Addendum No. 2

City of Kerrville Athletic Complex Field House

November 28, 2016

Project: City of Kerrville Athletic Complex Field House
Project No.: 20-1605

SHEET NUMBER A3.1

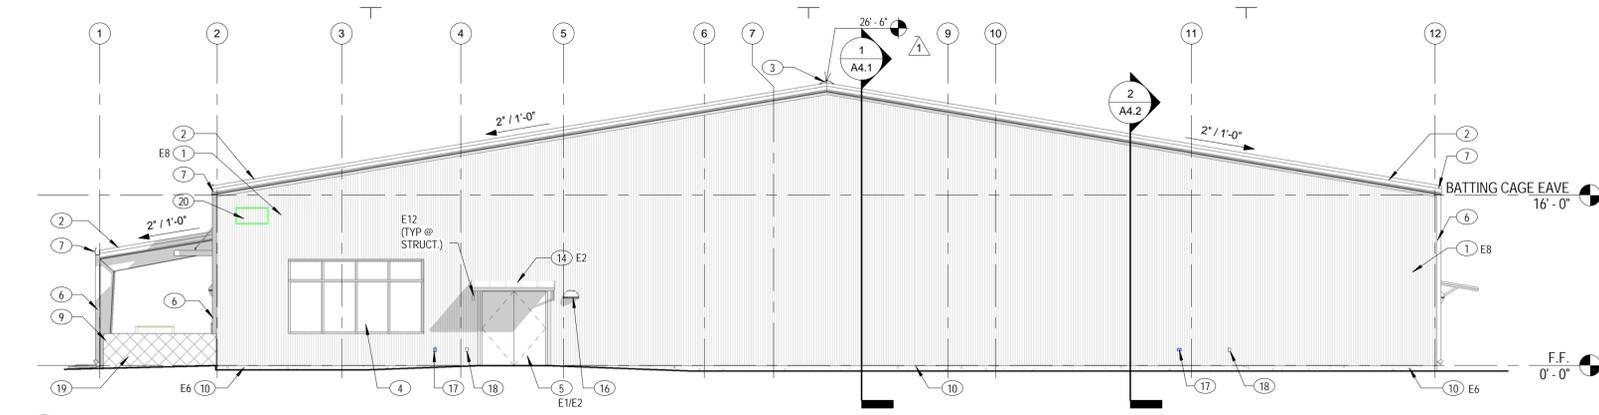
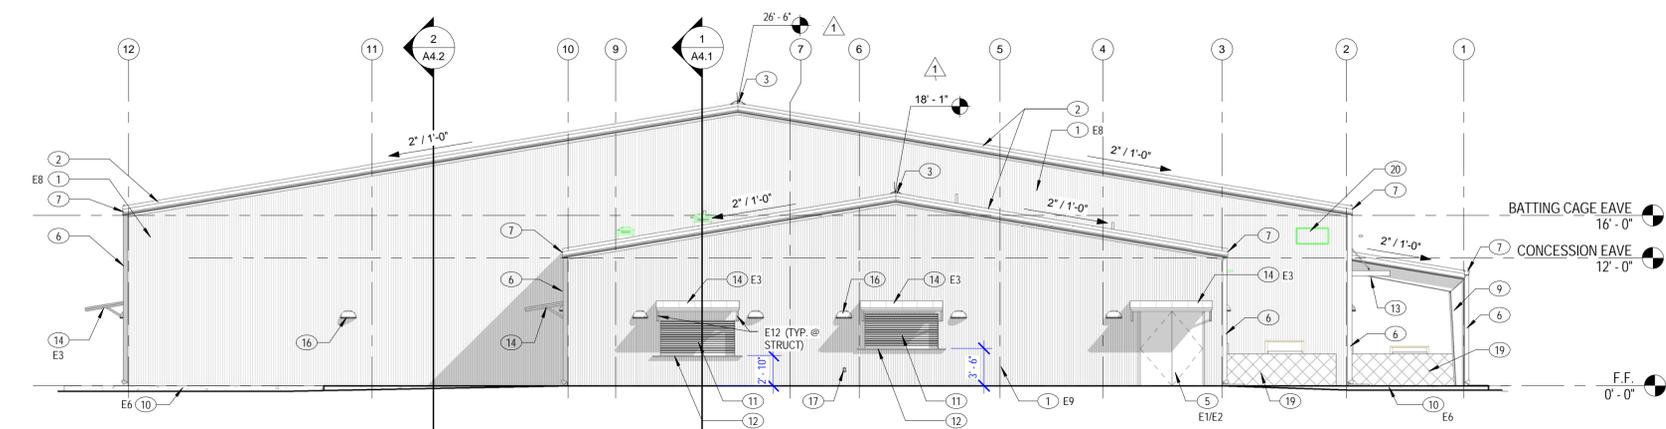
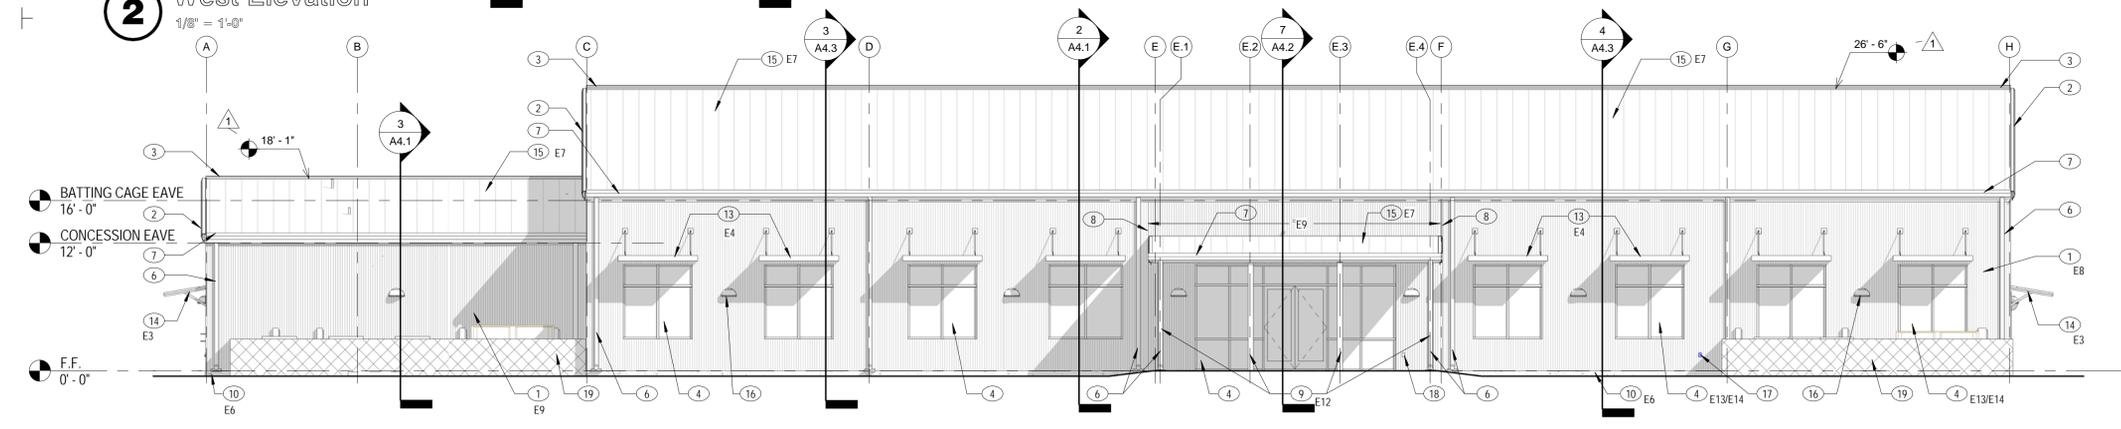
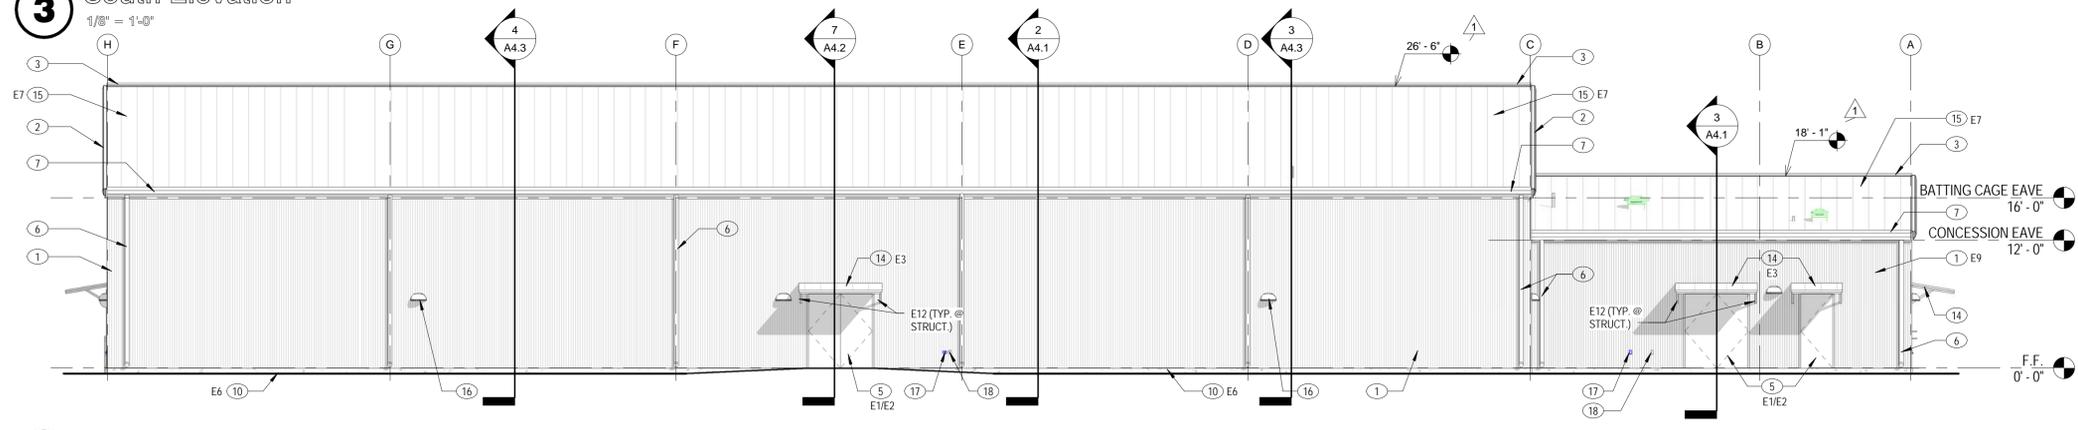
RESPONSE: Revise Metal Building Systems Specification Section 13340, Section 2.4, Item A. Provide MBCI SuperLok 16 in lieu of PBR Roof Panel. Revise Exterior Finish Schedule on Sheet A3.1, item E7 as indicated within this addendum.

Item No. A26: **SHEET A3.1:** Revise Exterior Finish Schedule, Item E7 as shown.

EXTERIOR FINISH SCHEDULE				
NOTES: 1. FINAL SELECTION SHALL BE SELECTED BY ARCHITECT FROM FIELD MOCK-UPS AND MATERIAL SUBMITTALS. 2. TBD = COLORS AND TEXTURES TO BE DETERMINED BY ARCHITECT FROM FIELD MOCK-UP. 3. REFER TO SPECIFICATIONS FOR ADDITIONAL INFORMATION.				
MARK	DESCRIPTION	MATERIAL	FINISH / COLOR	COMMENTS
E1	HOLLOW METAL FRAMES	METAL (PRE-PRIMED)	SHERWIN WILLIAMS "SW 6677" GOLDENROD	-
E2	HOLLOW METAL DOORS	METAL (PRE-PRIMED)	SHERWIN WILLIAMS "SW 6677" GOLDENROD	-
E3	STEEL AWNING FRAMING (OVER DOORS)	METAL (PRE-PRIMED)	SHERWIN WILLIAMS "SW 6635" DETERMINED ORANGE	-
E4	STEEL CANOPY (OVER WINDOWS)	METAL	POWDER COAT SHERWIN WILLIAMS "SW 6677" GOLDENROD	-
E5	CONCRETE FLOOR (AT ALL EXTERIOR CONDITIONS)	CONCRETE	LIGHT BROOM FINISH	-
E6	CONCRETE FOUNDATION (VERTICAL SURFACE)	CONCRETE	PROVIDE RUBBED FINISH WHERE EXPOSED TO VIEW. CONTRACTOR OPTION: PROVIDE SMOOTH SKIM COAT FINISH.	-
E7	PRE-FINISHED METAL ROOF	24 GA. PRE-FINISHED METAL	MBCI GALVALUME PLUS OR APPROVED EQUAL	BASIS OF DESIGN, MBCI SUPERLOK 16 ROOF PANEL
